PROPOSED TANKER PARKING AT RUSWARP S.P.S.

ROAD SAFETY AUDIT STAGE 1/2

APRIL 2013

4. Appendix A – Plan of Items Raised in the Audit

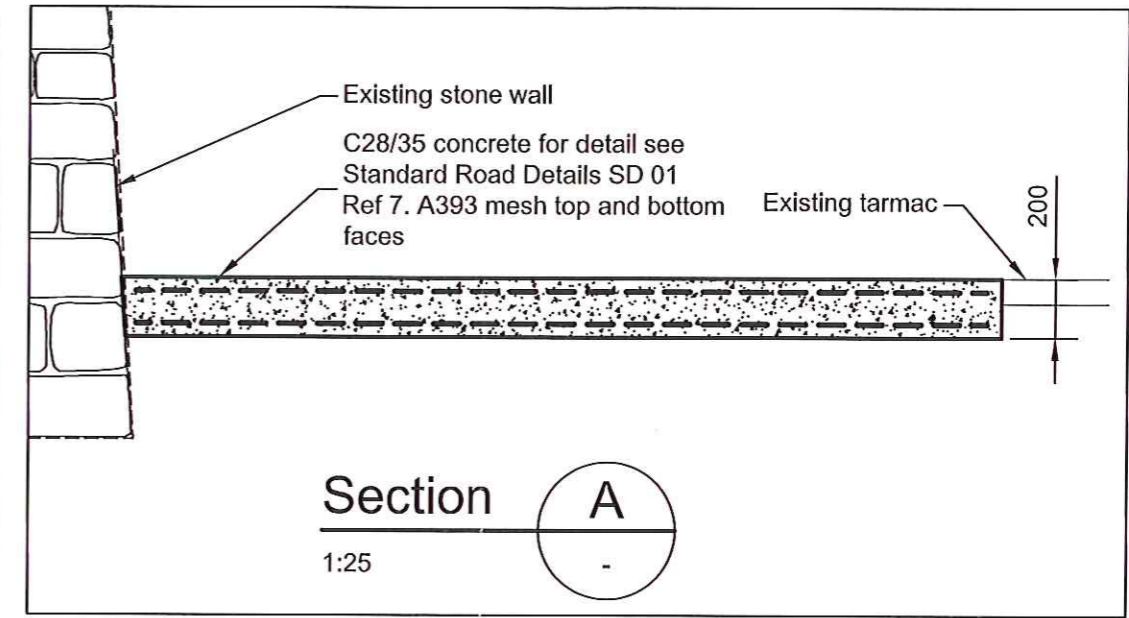
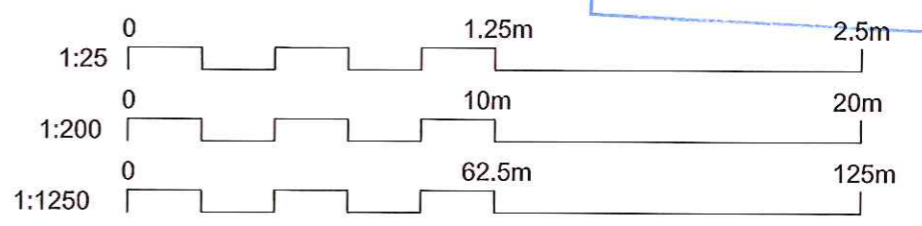
A1.1 PROBLEM

Location: E - East of proposed extended vehicular crossing

Summary: Crossing phone close to swept path

Description: It was noted on site that the existing crossing phone is within the vicinity of the proposed extended vehicular crossing. This could result in a vehicle using the crossing colliding with the crossing phone resulting in injury to the driver.

A1.2 PROBLEM

Location: A – Lay-by.

Summary: Vehicles parked in the lay-by could prevent a tanker accessing the pumping station

Description: It was observed on site that the existing road markings denoting parking restrictions are missing end bars and a glass recycling bank is located adjacent to the lay-by. This could encourage vehicles to park in the lay-by thus preventing a tanker accessing the pumping station. A tanker waiting to access the lay-by immediately after the 90 degree bend after the bridge could result in shunt type collisions.

A1.3 PROBLEM

Location: D – East of proposed extended vehicular crossing.

Summary: Over-run of verge resulting in damage to verge and footway

Description: A vehicle carrying out a reversing manoeuvre onto the proposed hard standing may over run the verge resulting in damage to the verge and footway edge producing a trip hazard for pedestrians.

A1.4 PROBLEM

Location: B – Eastbound carriageway adjacent to existing lay-by

Summary: Swept path encroaching into carriageway

Description: A vehicle carrying out a reversing manoeuvre onto the proposed hard standing will encroach into the eastbound carriageway potentially colliding with a passing vehicle resulting in damage and injury.

A4.1 PROBLEM

Location: C – Footway adjacent to vehicular crossing

Summary: Potential collision with pedestrians

Description: A vehicle carrying out a reversing manoeuvre onto the proposed hard standing could collide with a pedestrian using the footway, causing injury.

Recommendation: Relocate crossing phone away from vehicular crossing..

Recommendation: Relocate the recycling bank away from the lay-by and discourage people parking in the layby by ensuring that the waiting restrictions are enforceable.

Recommendation: Ensure that the proposed extension to the vehicular crossing provided sufficient area to carry out the manoeuvre without encroaching onto the verge.

Recommendation: Ensure that the proposed extension to the vehicular crossing provided sufficient area to carry out the manoeuvre without encroaching onto the carriageway.

Recommendation: Ensure that adequate personnel are present to guide the driver and prevent pedestrians being in the vicinity of the vehicle when carrying out the reversing manoeuvre.
